**APPLICATION FOR CERTIFICATE OF APPROPRIATENESS
DESIGN REVIEW
CITY OF GAHANNA PLANNING COMMISSION**

*Site Address 77 GRANVILLE ST. GAHANNA, OHIO 43230

*Special Information Regarding the Property and its Proposed Use: EXISTING WENDY'S RESTAURANT. EXISTING SOLARIUM ON FRONT TO BE REBUILT WITH FULL HEIGHT WALLS. EXTERIOR + INTERIOR RENOVATIONS TO UPDATE TO CURRENT WENDY'S FINISHES.

STAFF COMMENTS

WENDY'S
77 GRANVILLE ST

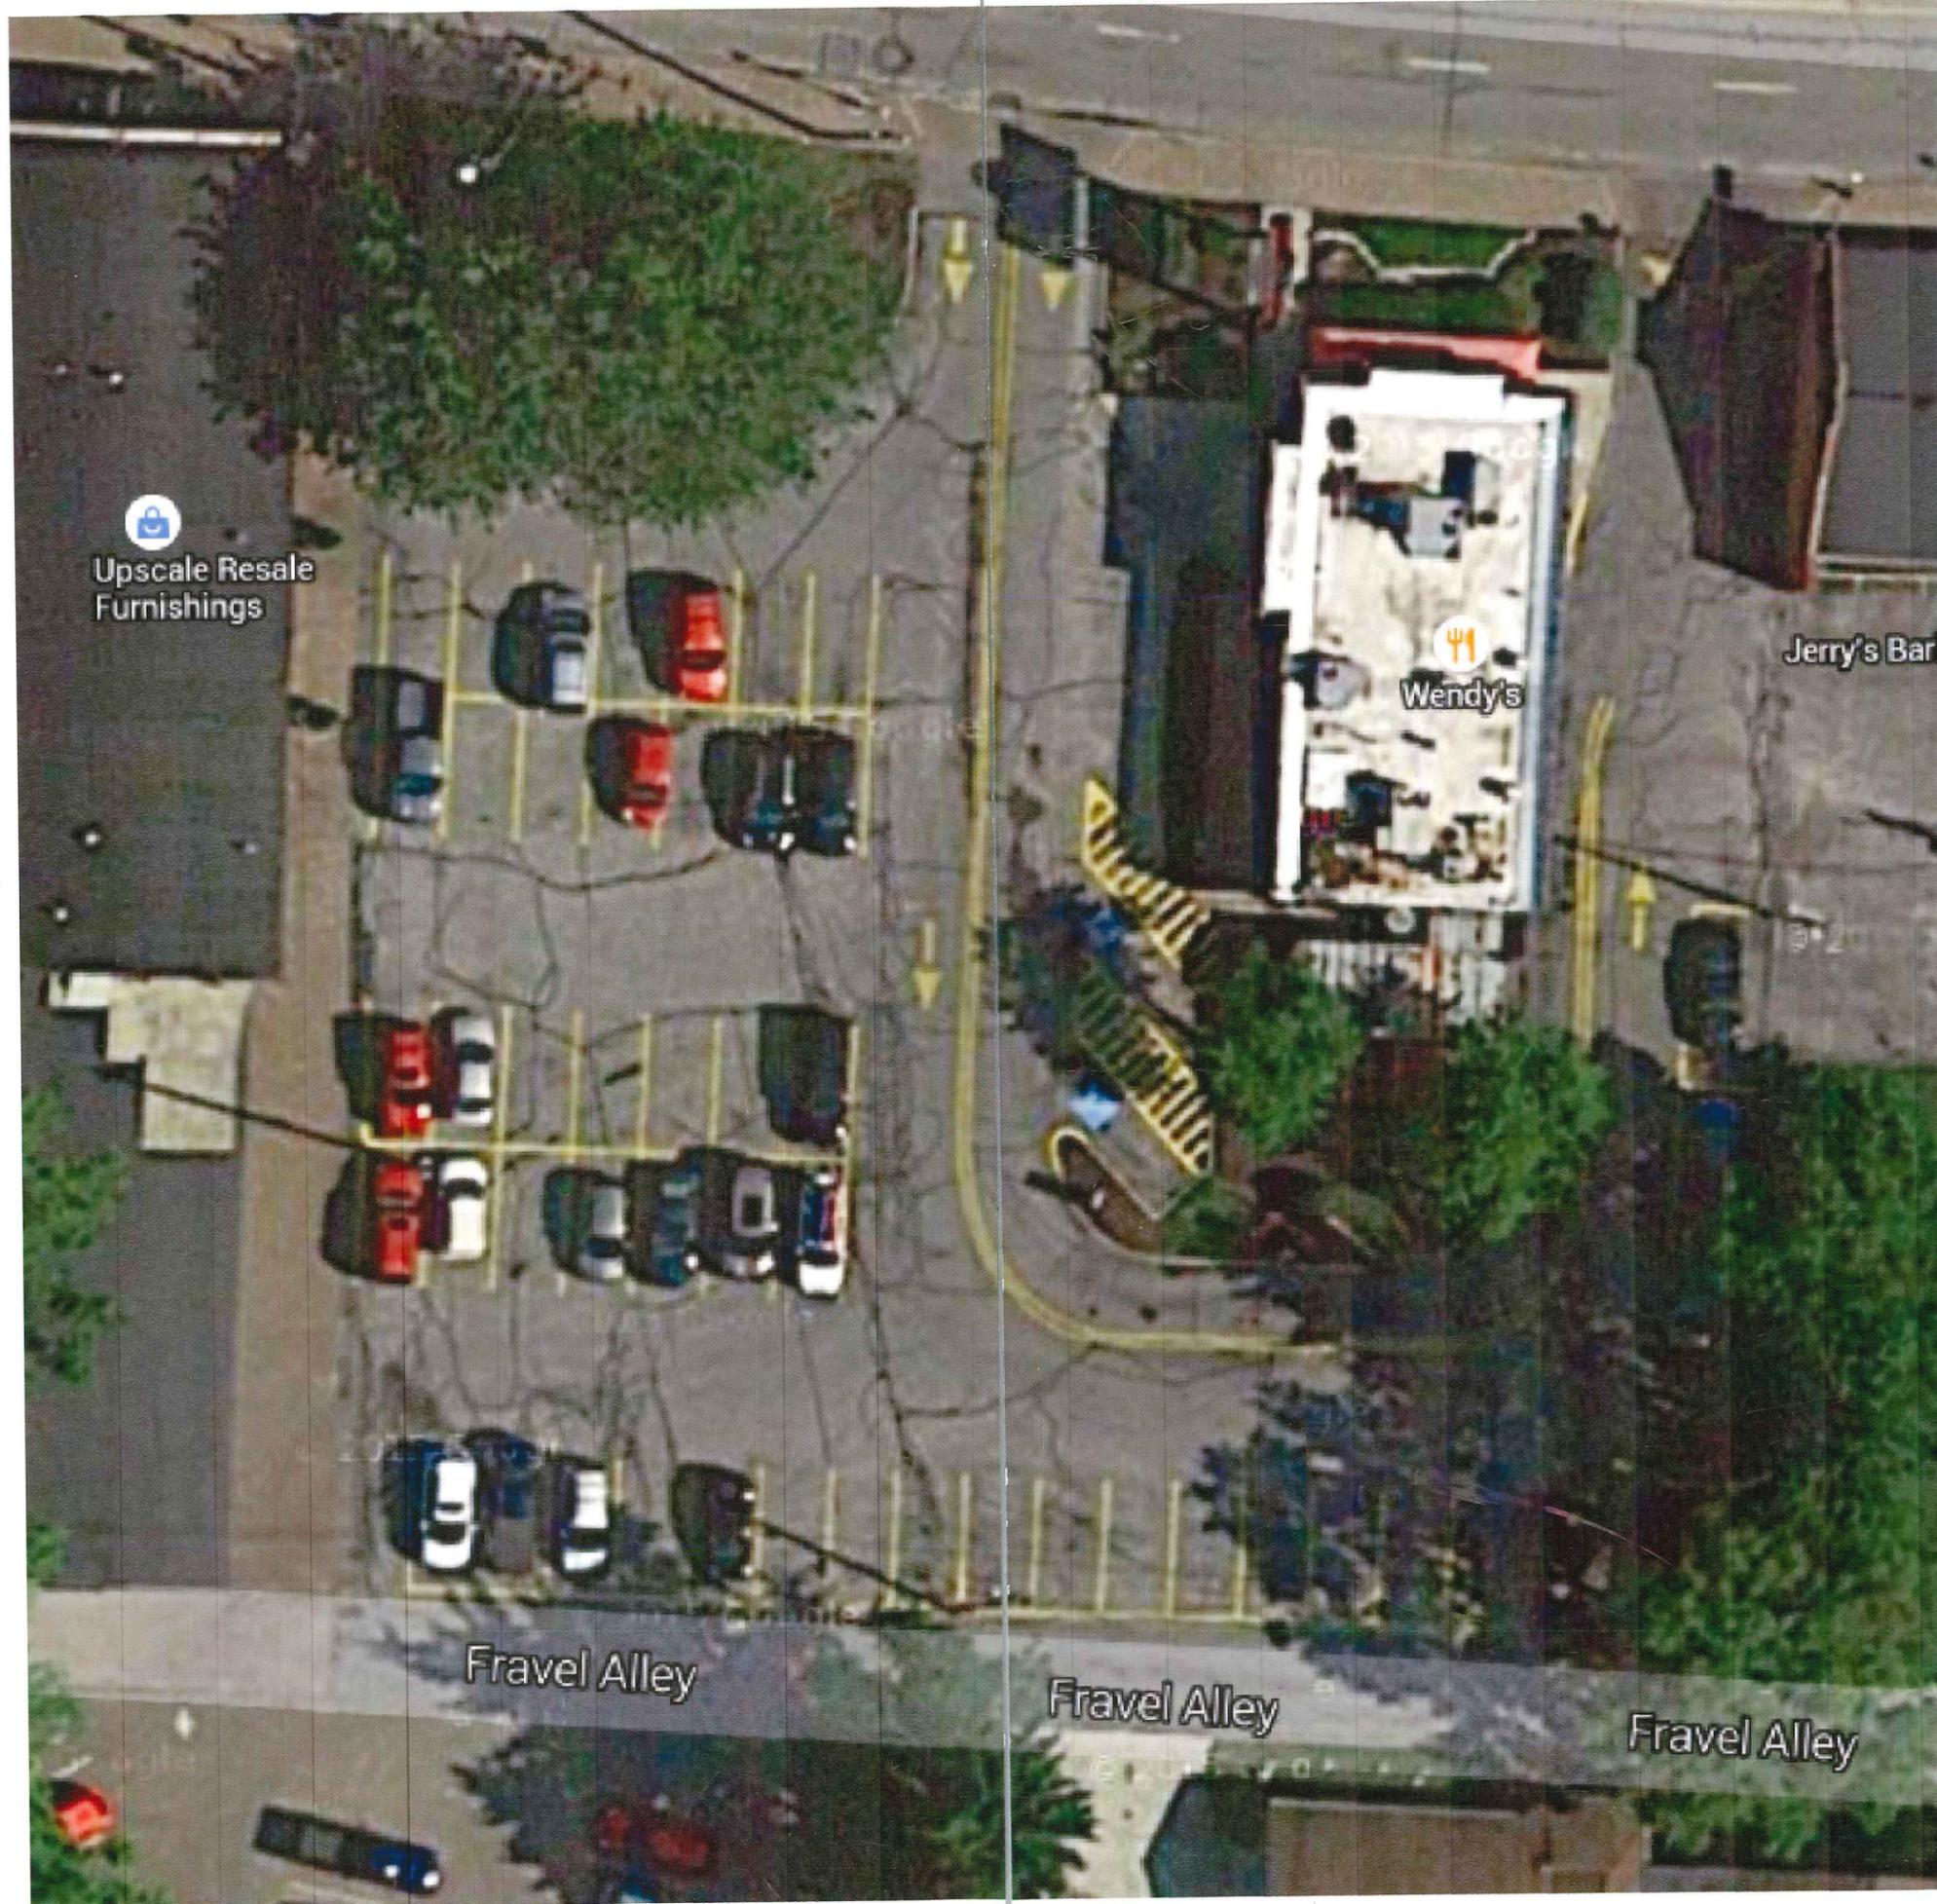
The existing asphalt, concrete and landscaping will remain, and the asphalt will be sealed and restriped.

EXTERIOR ELEVATIONS

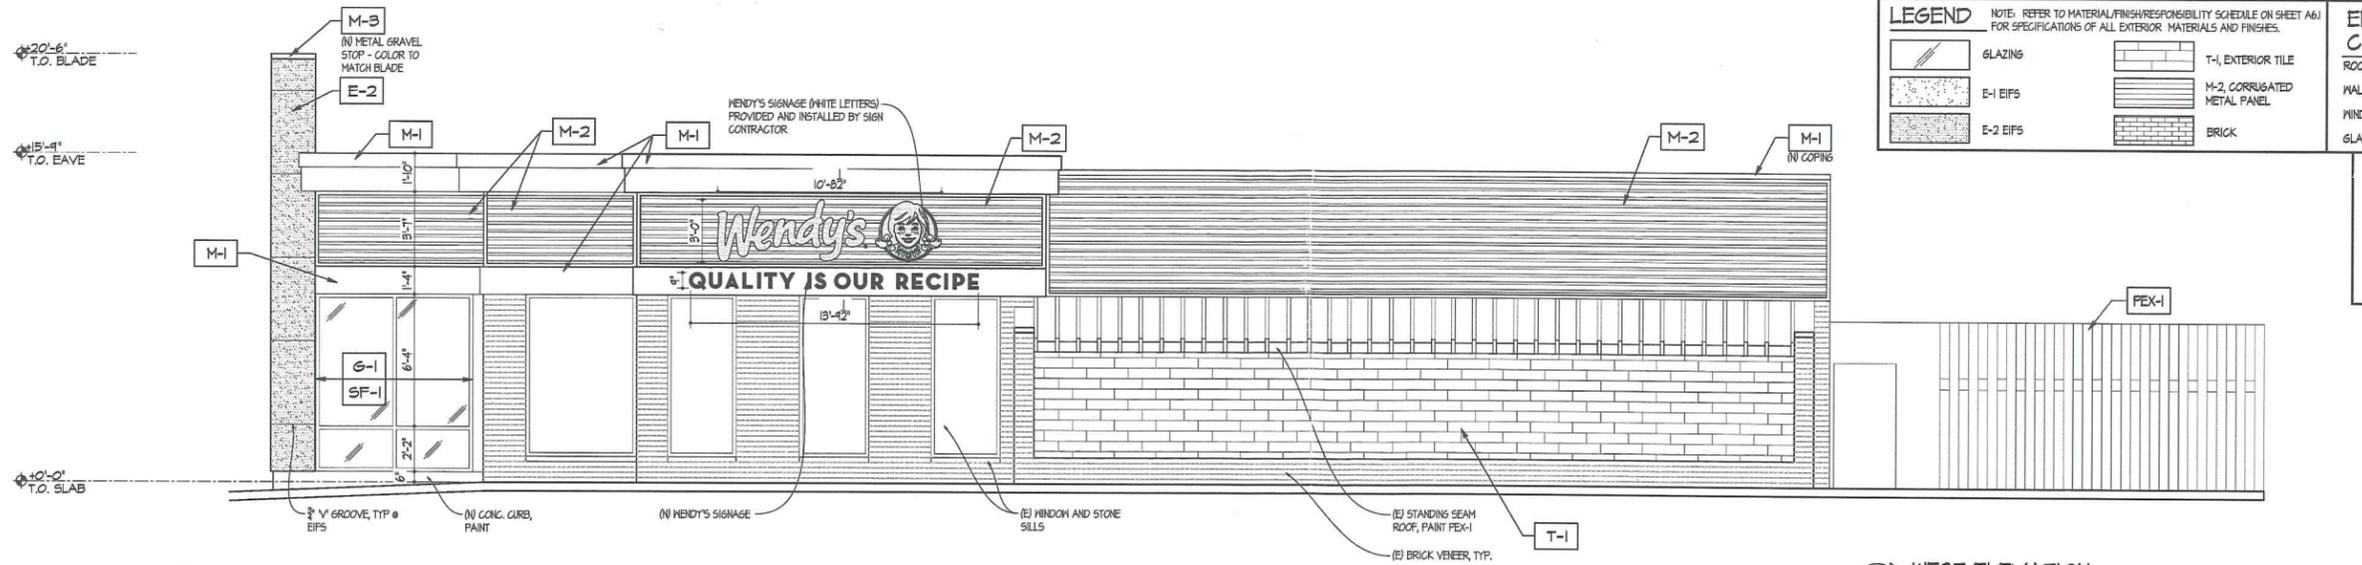
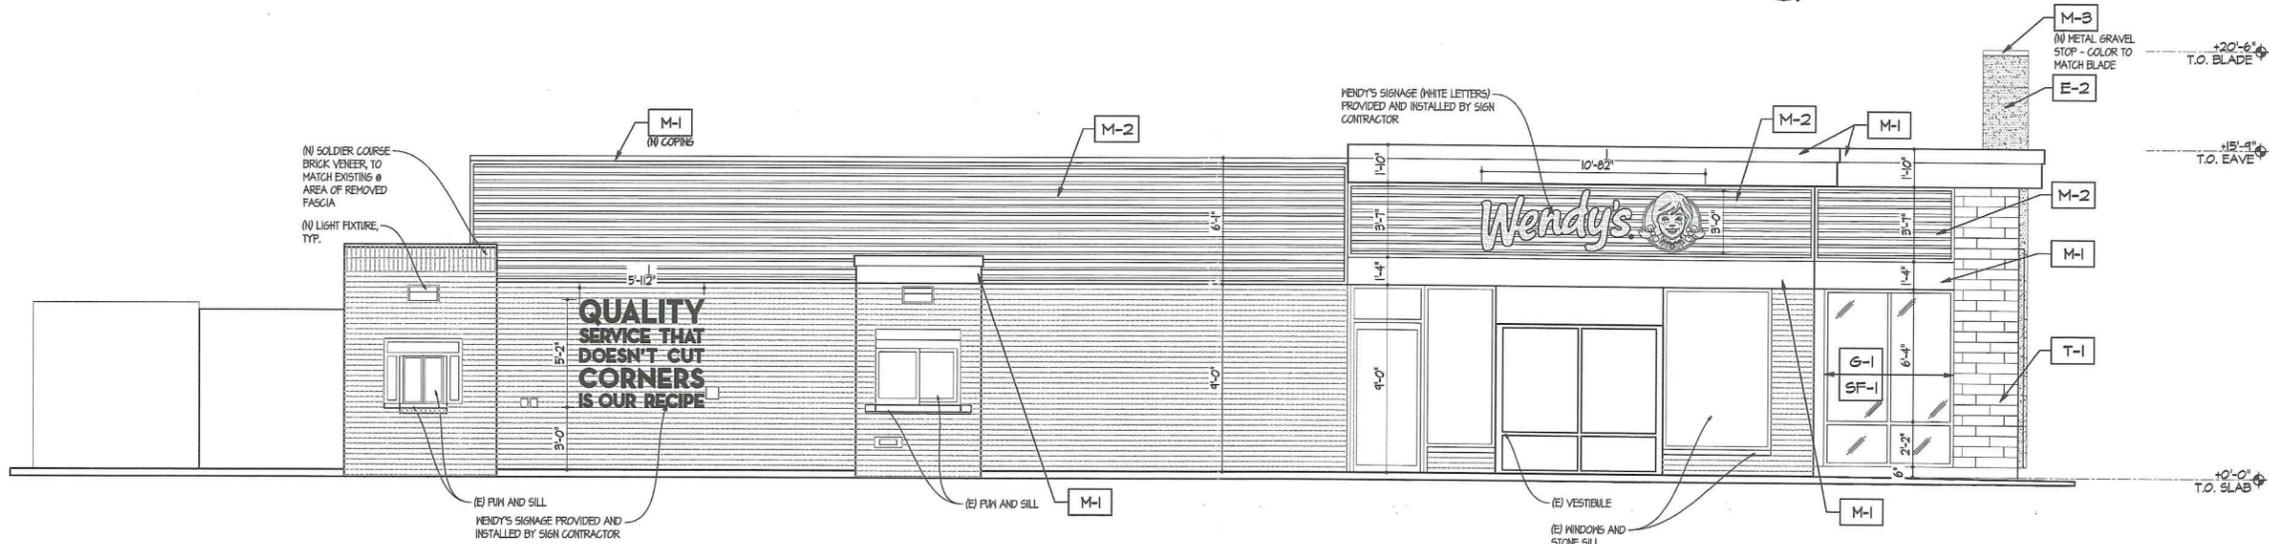
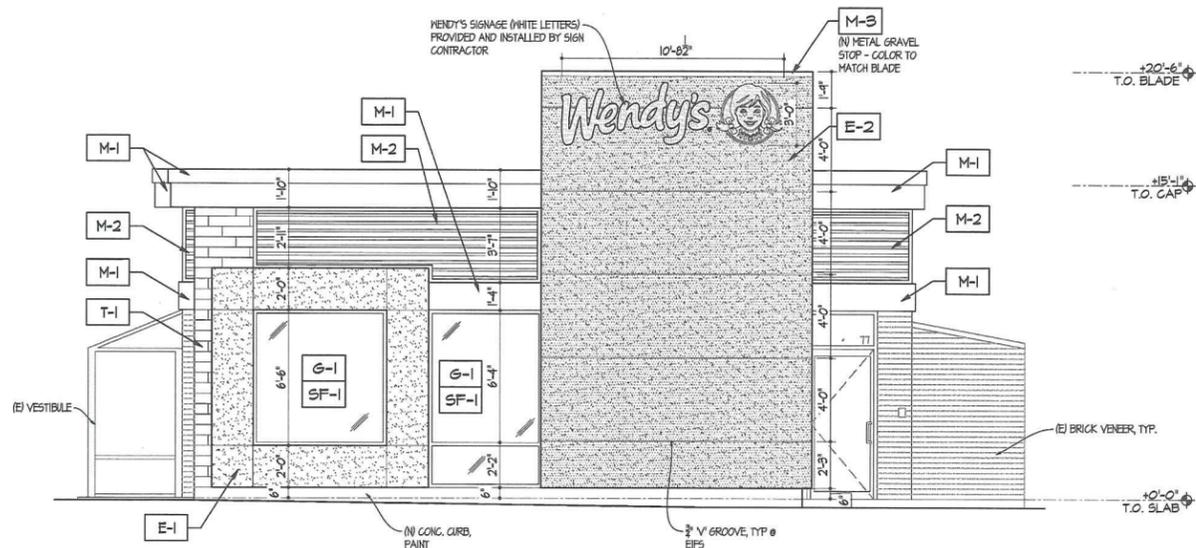
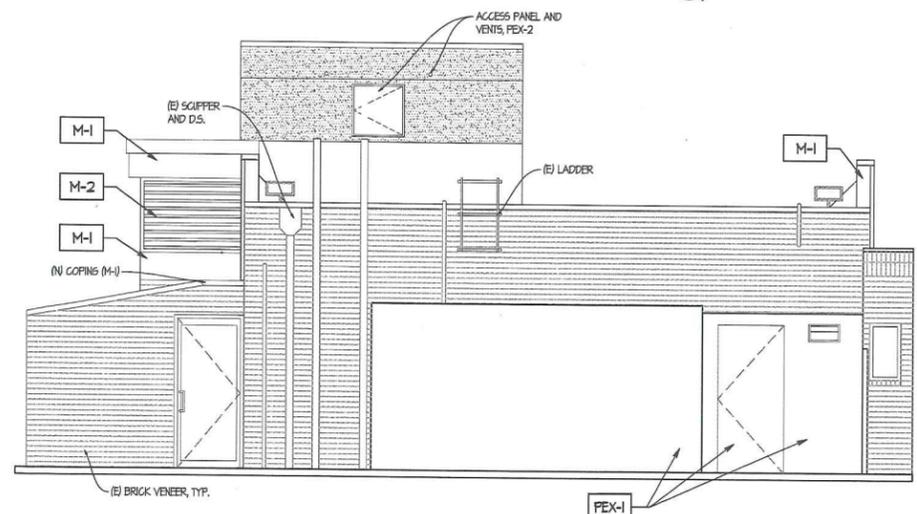
This existing restaurant is proposed for a total re-imagining inside and out. There is virtually no change to the existing footprint. The existing solarium on the north façade will be replaced by full height walls, and a 20'6" red EIFS blade and a grey EIFS window frame feature will be installed. Some of the existing masonry will be retained, while new exterior tile will be added as illustrated. Corrugated metal panels in Dark Bronze will be added to each façade in varying amounts.

New wall signage is proposed for the north, east and west facades, and is illustrated in the submission materials.
